CERTIFICATE OF APPROPRIATENESS

Applicant: Michael Kravets, A.I.A., Heights Venture Architects LLP, for Anas Dib, SRC Congress Owner LP, owner

Property: 213 Milam (801 Congress), Lot 4 & 5, Tract 12A, Block 19, SSBB Subdivision. The property includes a historic four-story 57,180 square foot brick storefront building situated on a 12,000 square foot corner lot.

Proposal: Alteration – Remove the existing non-original storefront system and replace with new glass and wood panel storefronts.

NORTHWEST ELEVATION – FRONT FACING MILAM STREET

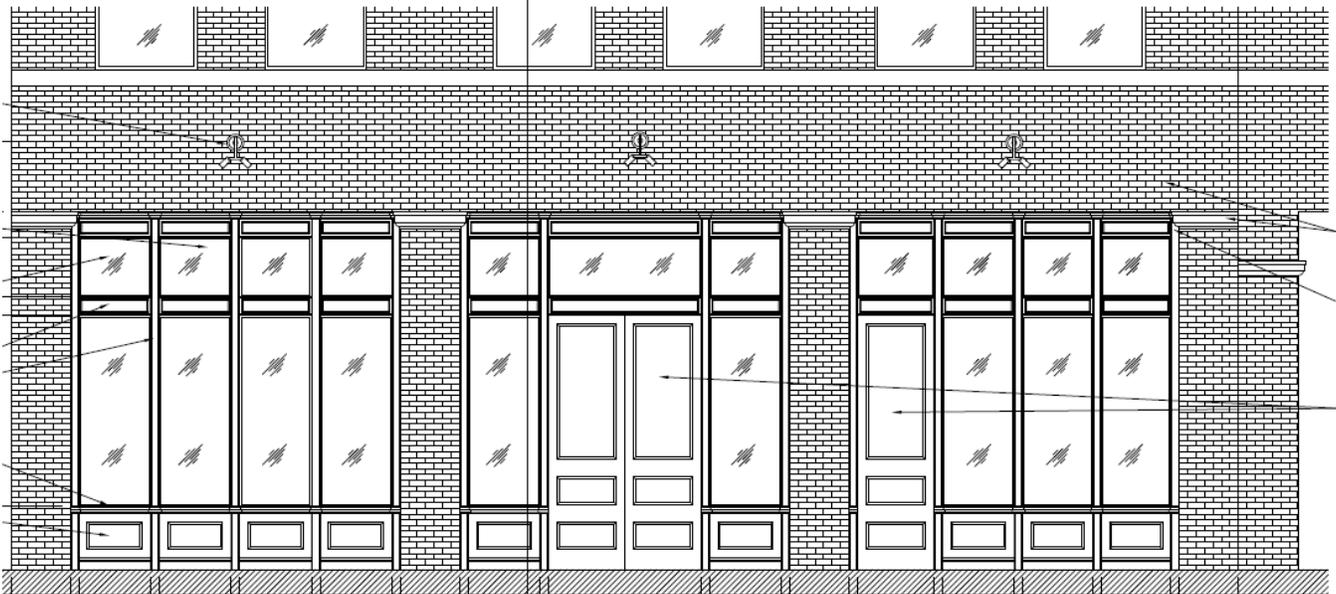
**Front Elevation:
(Northwest)** The existing brick storefront features three bays. Each bay is separated by brick columns. The existing aluminum storefronts are not original. The northern bay includes two tall glass panes. The central bay includes a set of doors flanked by glass panes. The southern bay includes a door and two panes of glass. All three bays are topped with a transom consisting of eight windows (two rows of 4 windows).

The proposed northern bay will include four sections, each consisting of wood panels and glass panes and topped by a transom. Each section will be separated by a wood column. The central bay will include a glass and panel double door topped by a transom and flanked on either side by wood panels and glass sections. The southern bay will include a single glass and panel door and three wood panels and glass sections. The transoms will be covered by awnings. See drawings for more detail.

AWNING DETAIL

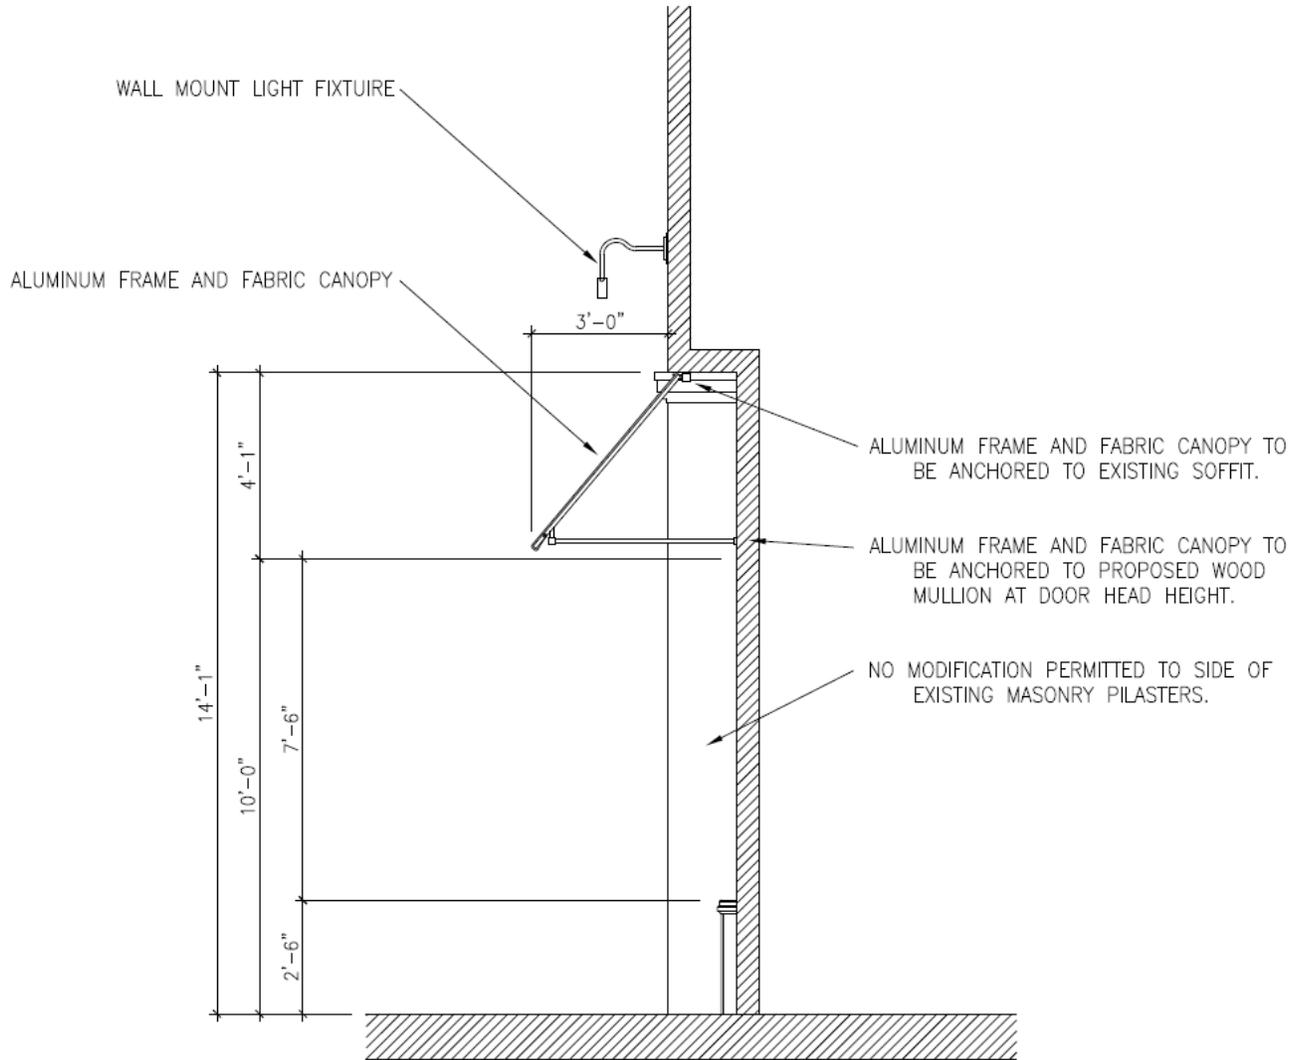
The existing storefront will be removed. All existing masonry is to remain and will not be altered. The proposed storefront will be inserted into the existing openings. The northern bay will include four 2'-10" wide sections, each consisting of a 2'-6" tall bottom wood panel, a 7'-6" tall glass pane, 9" tall wood panel, 2'-4" tall glass transom, and topped by a 1'-0" tall panel. Each section will be separated by a 4" wood column. The central bay will include 6'-0" wide glass and panel double door topped by a transom and will have a 2'-10" wide panel and glass section on either side. The southern bay will include a single 3'-0" wide glass and panel door and three 2'-10" panel and glass sections. The transoms will be covered by new awnings. The awnings will be located 10' from the ground and will be 3'-0" deep and 4'-1" tall. See drawings for more detail.
